Access Compliance Report Public Rights-of-Way (Pedestrian Signals)

Main Street: FAIRMONT_BLV Cross Street: OLD_RANCH_RD Location: SW

ADA ID: SGAT210921144252 Signal Type: One Push Button-Non APS Overall Compliance: No Severity Scores: BTN 1: 10 BTN 2: N/A No BTN: N/A

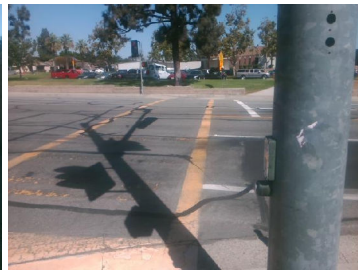
OC Std/PROW: MUTCD 4e.08

Possible Solutions: Replace Signal Push Button With APS Button. Remove & Relocate Sign.
